**ADDENDUM NO. ONE**

January 9, 2017

**Sanctuary & Classroom Addition  
THE CARPENTER'S CHRISTIAN CHURCH  
Harrodsburg, Kentucky**

Re: Addendum No.1  
The Carpenter's Christian Church  
Harrodsburg, KY  
BK Project No: 16069.01

**LOWER LEVEL POWER PLAN**  
SCALE: 1/8"-1'-0"

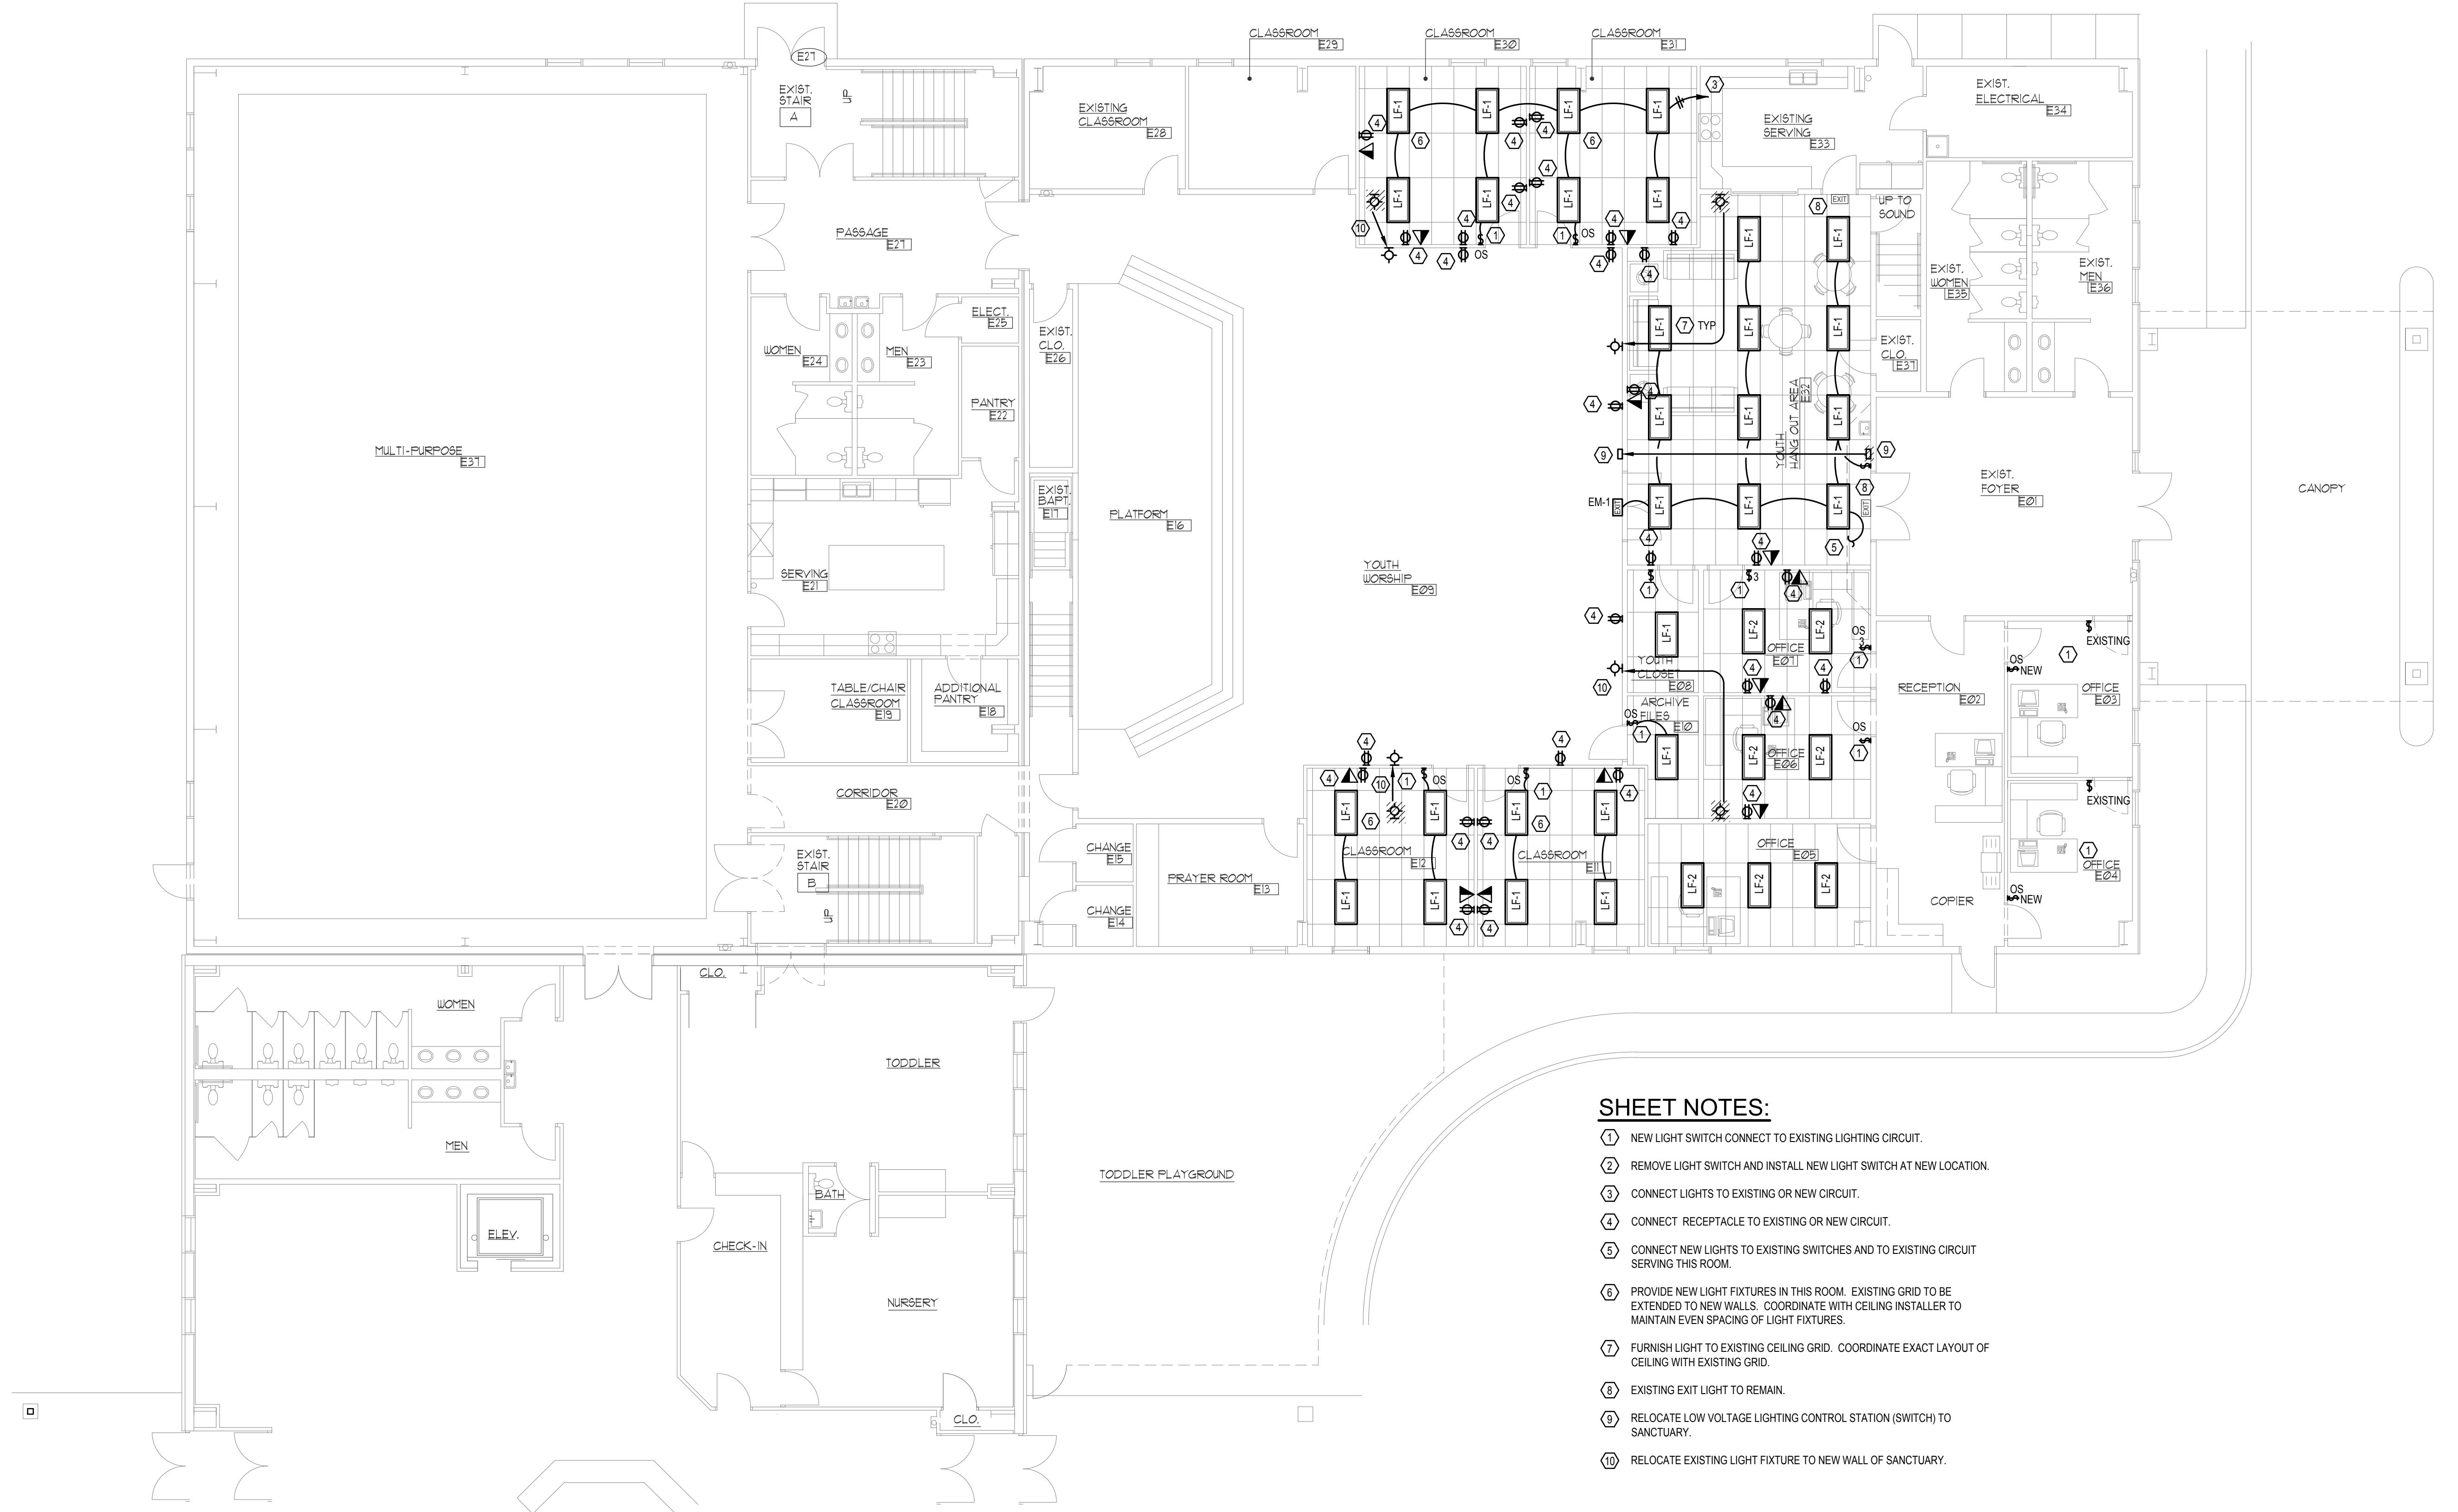
- Panel "A" shall be located adjacent to the MDP.
- Provide Circuit from MDP to Elevator, Provide disconnect switch with auxiliary contacts. Coordinate full electrical requirements with elevator manufacturer.
